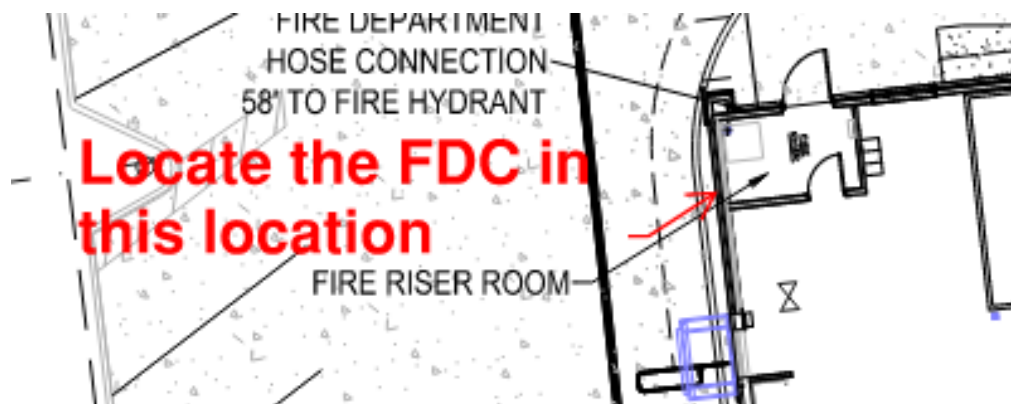
2. The access around the building (north side, is shown to be only 10 feet wide; it preapplication meetings, I believe that we had discussed a 15-foot drive aisle (possibly 14 foot?). In any case, ten feet is a bit too narrow. I would propose that the narrow landscape area to the north be minimized (reduced in width) and constructed as a raised rolled curb that is designed to withstand the weight bearing requirements of an 80,000-pound rig. Note the fire hydrant shall be relocated.

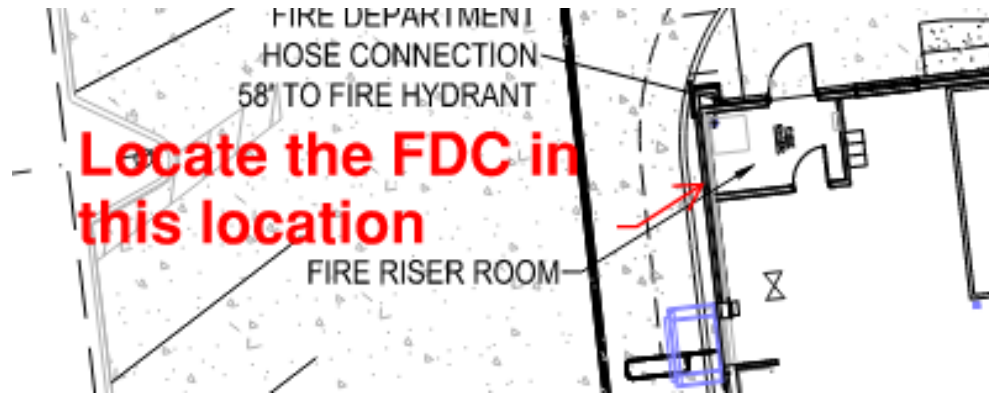
6. The applicant shall provide an auto turn analysis indicating that apparatus can navigate all portions of this site; NO PARKING – FIRE LANE signage is required for any portion of the access where the 20-foot clear width

requirement cannot be met. In this case, the applicant has provided an auto turn analysis for a portion of the site; the applicant shall update the analysis to include the right in/right out entry on the south portion of the site; see below and address when resubmitting:

Note – the area identified with the two blue rectangles is of particular concern. People tend to not stay within the lines and the 20-foot drive aisle on the south end creates a potential for delays in response specific to staged or waiting vehicles in this area. Ensure that this issue is addressed adequately or provide signage that states **NO PARKING OR STANDING – FIRE LANE** in this area (area shown on west side of building... south end as well as the south side of the building).

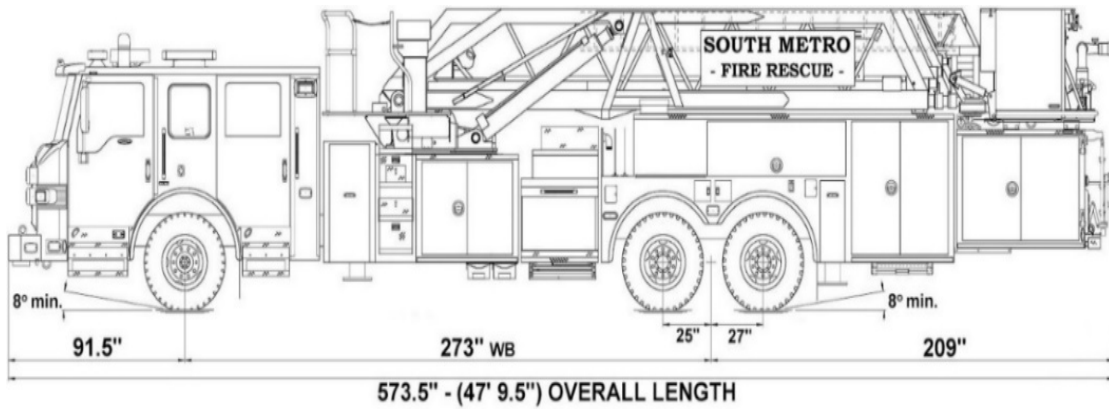
7. The applicant shall provide signage on both sides of the north access; east side shall state "ONE WAY" and the west side shall have signage that states "DO NOT ENTER"
8. The applicant shall provide NO PARKING – FIRE LANE signage for any portion of the access where the 24-foot clear width requirement cannot be met; areas that are required to have this signage are located on both the north and sides of the building. See below for areas highlighted in yellow:
